HISTORIC AND DESIGN REVIEW COMMISSION

HDRC CASE NO: 2019-699
ADDRESS: 911 N PINE ST
913 N PINE ST
915 N PINE ST
917 N PINE ST
LEGAL DESCRIPTION: NCB 531 (PINE AT HAYS {IDZ}), BLOCK 13 LOT 25
NCB 531 (PINE AT HAYS {IDZ}), BLOCK 13 LOT 26
NCB 531 (PINE AT HAYS {IDZ}), BLOCK 13 LOT 27
NCB 531 (PINE AT HAYS {IDZ}), BLOCK 13 LOT 28
ZONING: IDZ, H
CITY COUNCIL DIST.: 2
DISTRICT: Dignowity Hill Historic District
APPLICANT: Ricardo Turrubiates/Terramark
OWNER: K/T TX Holdings & T/A Apartments Inc
TYPE OF WORK: Construction of two, 2-story residential structures
APPLICATION RECEIVED: July 17, 2020
60-DAY REVIEW: Not applicable due to City Council Emergency Orders
CASE MANAGER: Edward Hall

Historic and Design Review Commission
Design Review Committee Report

HDRC Presentation - Final Approval

CONTEXT
STIPULATIONS

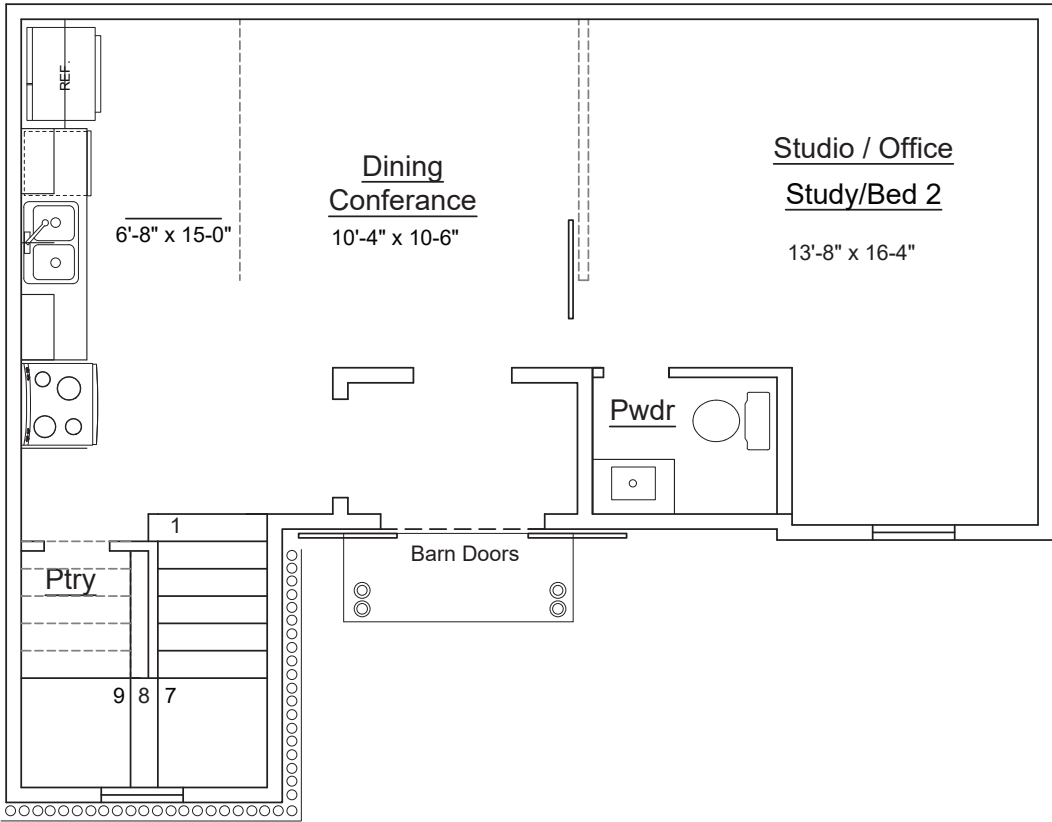
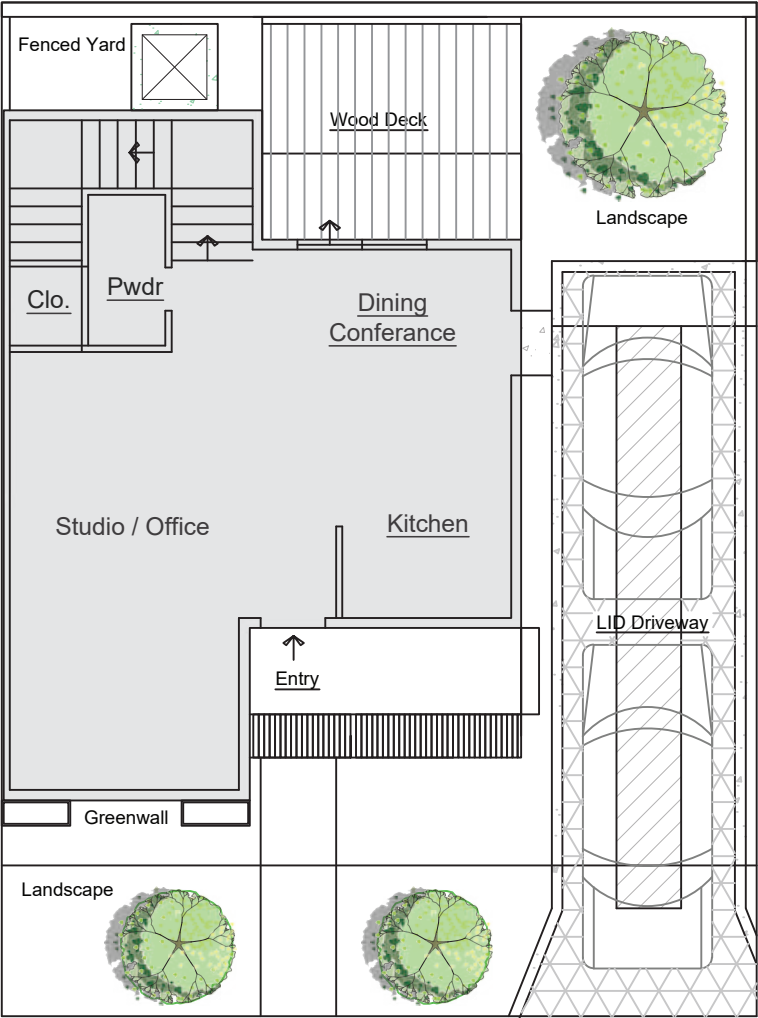
- i. That the applicant incorporate traditional entrance elements into the design of each unit. By traditional entrance elements, staff is referring to both the massing and profile of a porch, as found on historic structures throughout the district.
- Entry Door incorporated was changed from a barn door to a Commercial 1 Lite Full glass door which can be found on neighboring properties.
- Additions were Entry Canopy & Metal columns that resemble the entry to the Terramark office building.
- Also the new design has a expanded porch with a sidewalk which now comes off the common drive.

CONTEXT

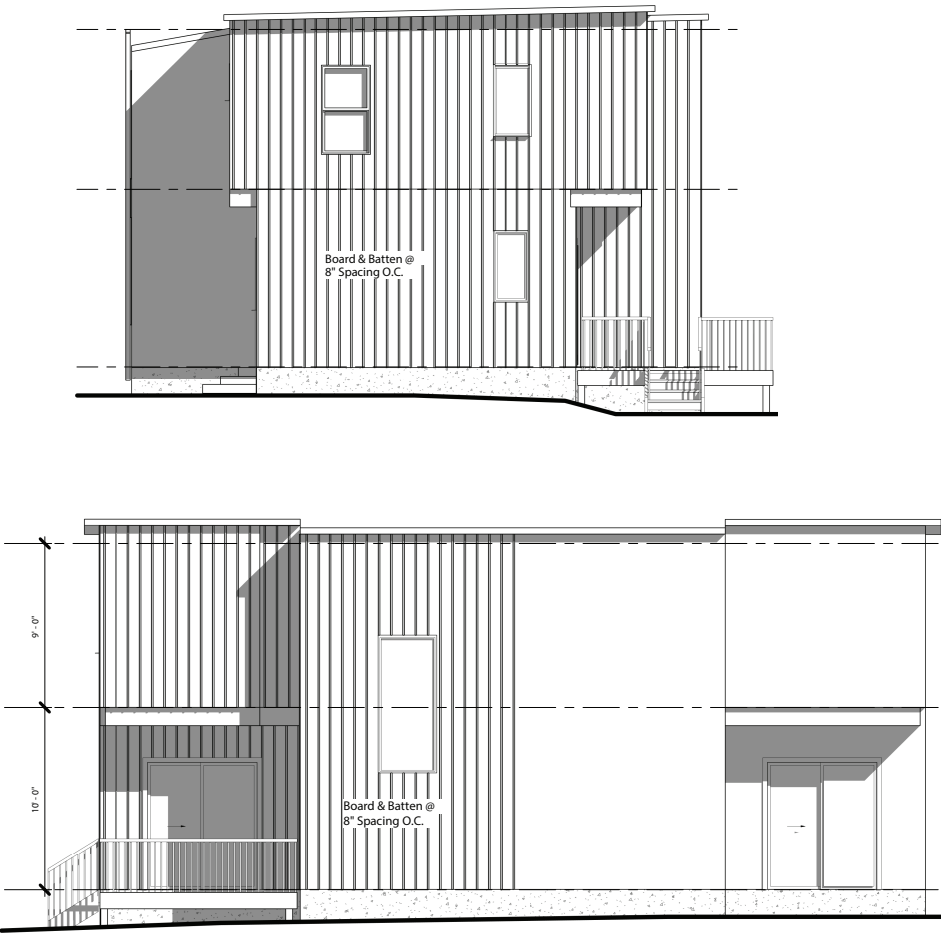
- iii. That the applicant propose roof forms that are consistent with the Guidelines and that are consistent with those found historically within the District. The proposed roof forms feature an overall massing that is atypical for those found historically in the district given their total span (width).
- The roof forms follow that of a shed per unit however as a building the roof forms resemble those of a GABLE
 - The roof pitch has been increased to a 3:12 consistent to existing forms found in the District and are in keeping with conceptual plans approved by HDRC.
-

- The roof forms follow that of a shed per unit however as a building the roof forms resemble those of a GABLE
 - The roof pitch has been increased to a 3:12 consistent to existing forms found in the District and are in keeping with conceptual plans approved by HDRC.

CONTEXT
STIPULATIONS

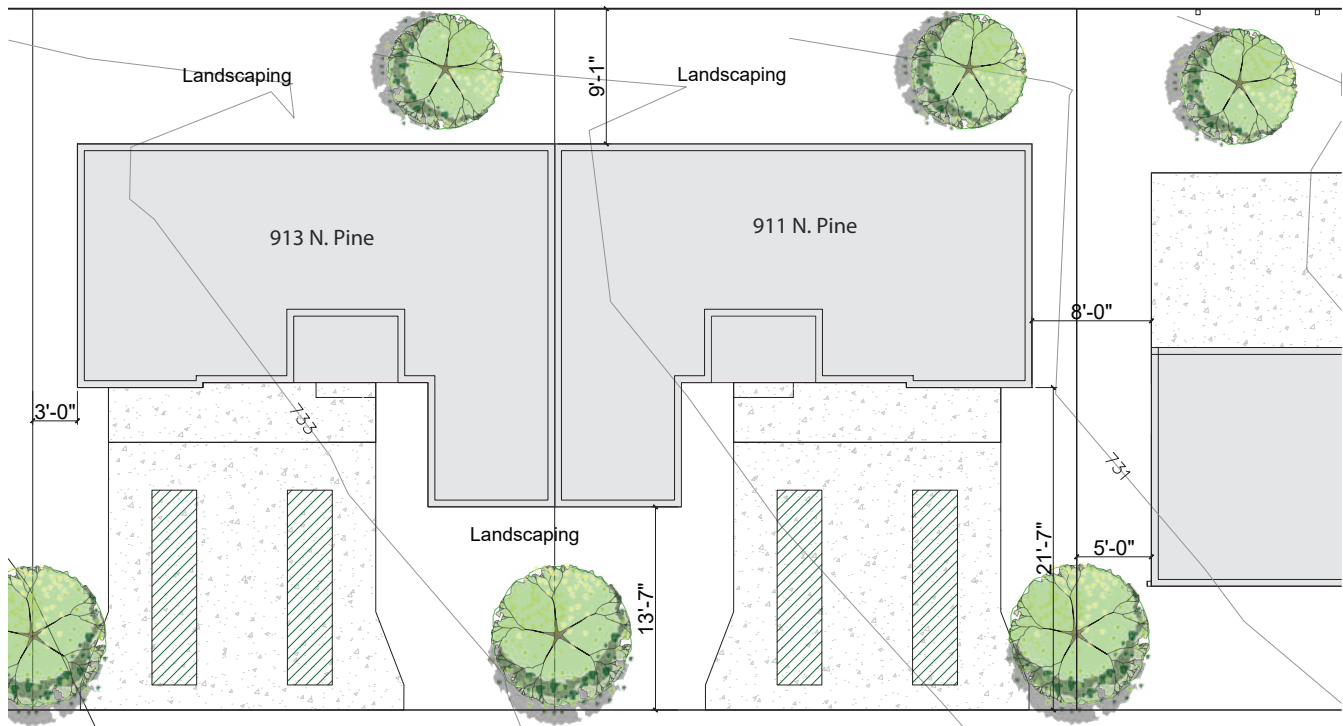
vii. That the applicant propose parking that is consistent with the Guidelines and does not result in a front yard parking condition as noted in finding s. Also that the proposed driveways be separated at lot lines. Continuous curb cuts that exceed the width typical for the district should be avoided.

-The proposed parking follows a tandum design which is located on the sides of each building, as requested and approved in the Conceptual Approval received from the HDRC.

-The locations have be identified on the floor plans (i.e. mechanical equipment at the rear and CPS meters on the east and west)

CONTEXT
STIPULATIONS

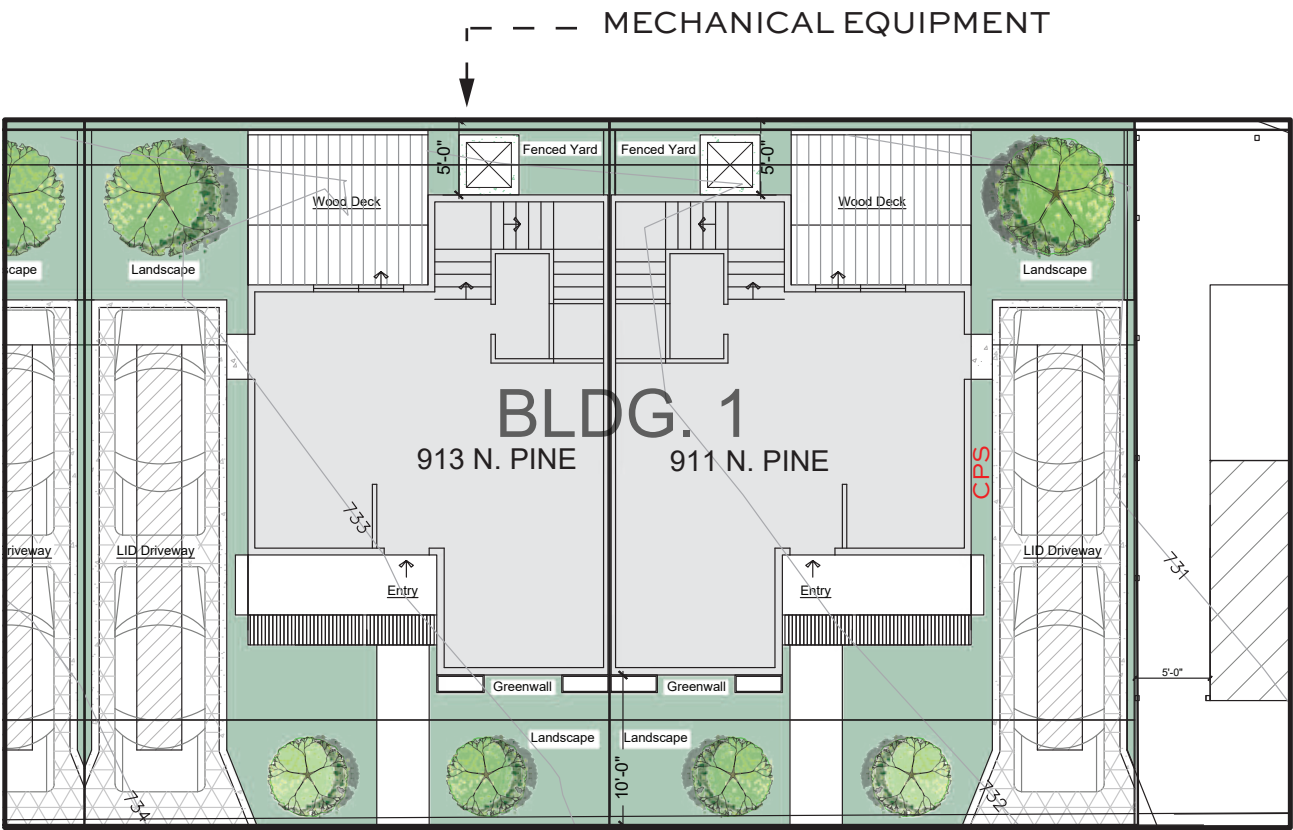
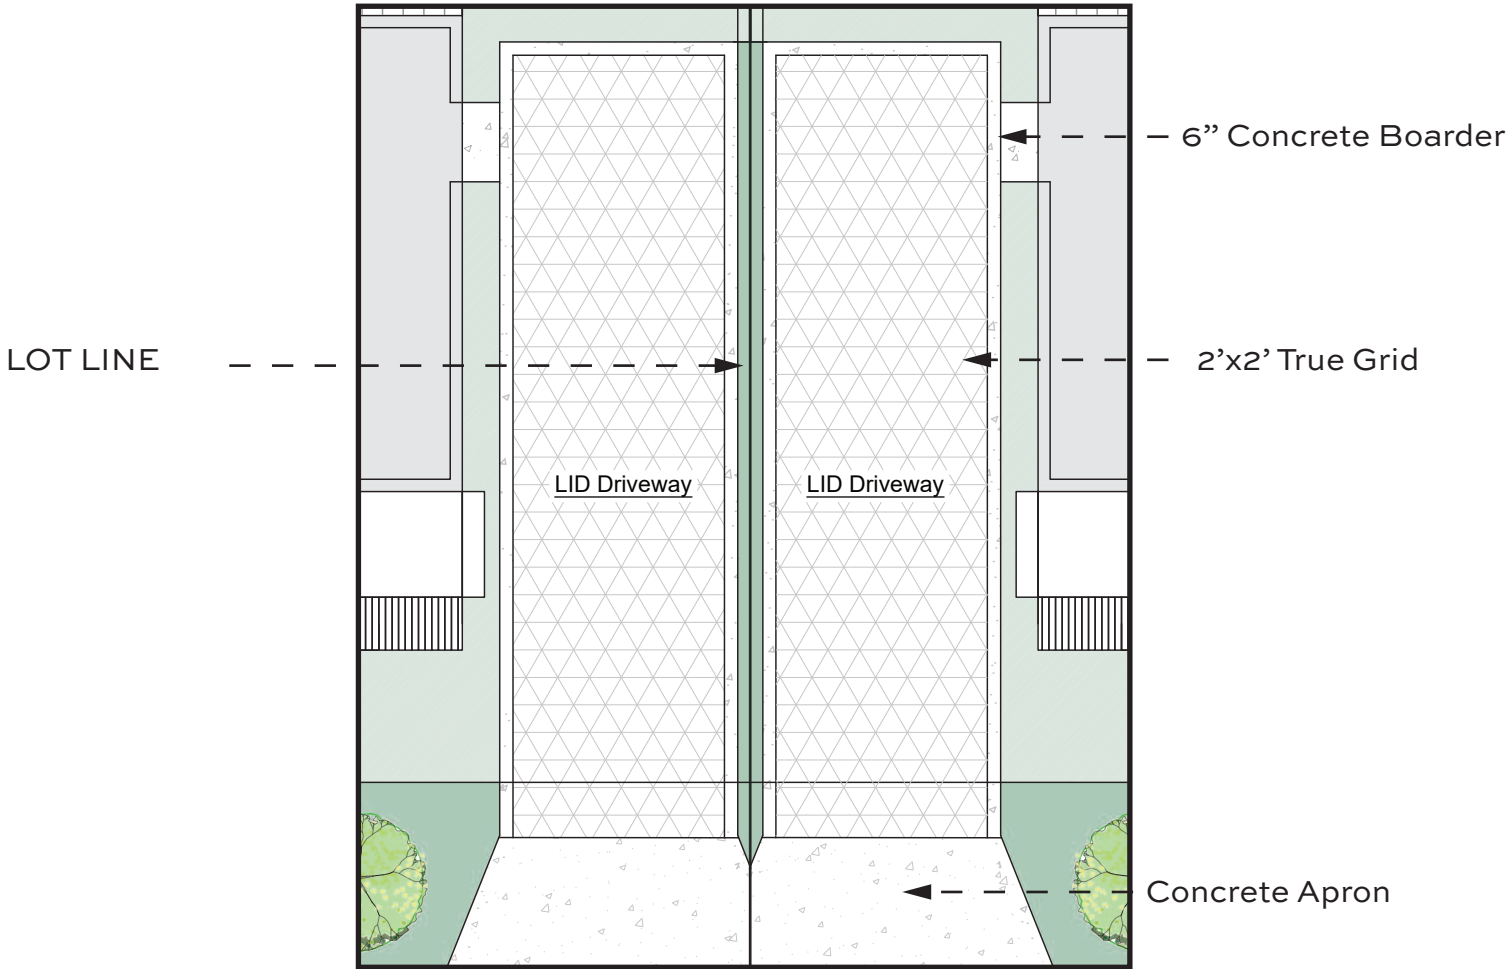
vii. That the applicant propose parking that is consistent with the Guidelines and does not result in a front yard parking condition as noted in finding s. Also that the proposed driveways be separated at lot lines. Continuous curb cuts that exceed the width typical for the district should be avoided.

-The proposed parking follows a tandum design which is located on the sides of each building, as requested and approved in the Conceptual Approval received from the HDRC.

Window Detail (Alum.)

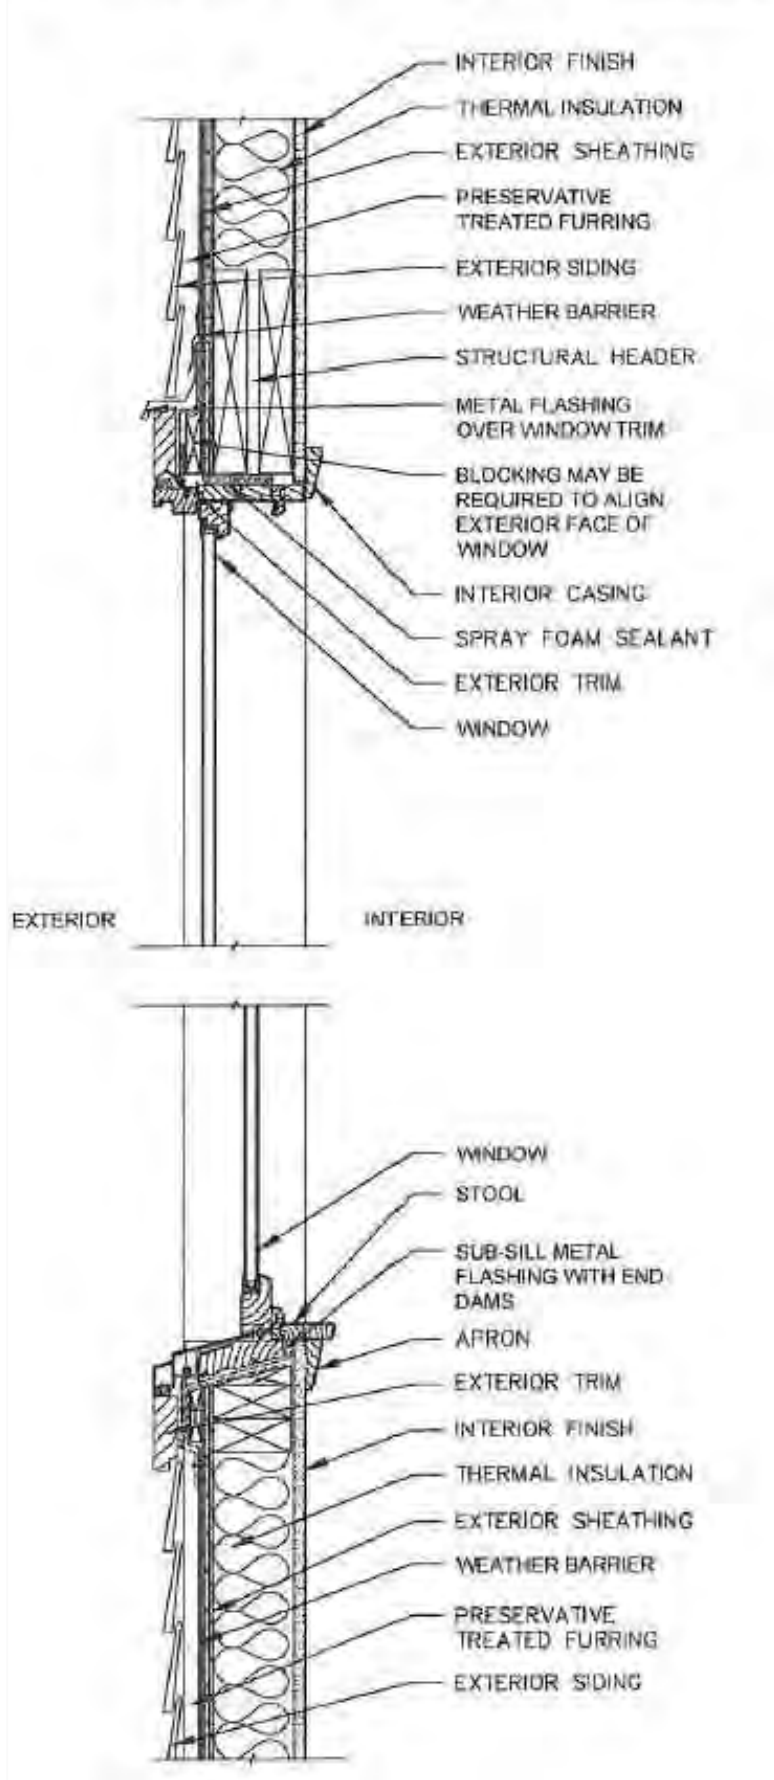
- p. **WINDOW MATERIALS** – The applicant has proposed to install aluminum windows. Staff finds that the proposed window should be consistent with staff's specifications for windows in new construction, which are noted in the applicable citations. The applicant has submitted a detailed wall section noting appropriate installation depths and profiles; however, the built example that the applicant has provided does not feature appropriate sill details.

- Plan to use aluminum windows in the color of Bronze that follow the recess guidelines.
- The Proposed windows meet the Historical Guidelines and are the same windows approved and constructed on the homes on Pine Street.
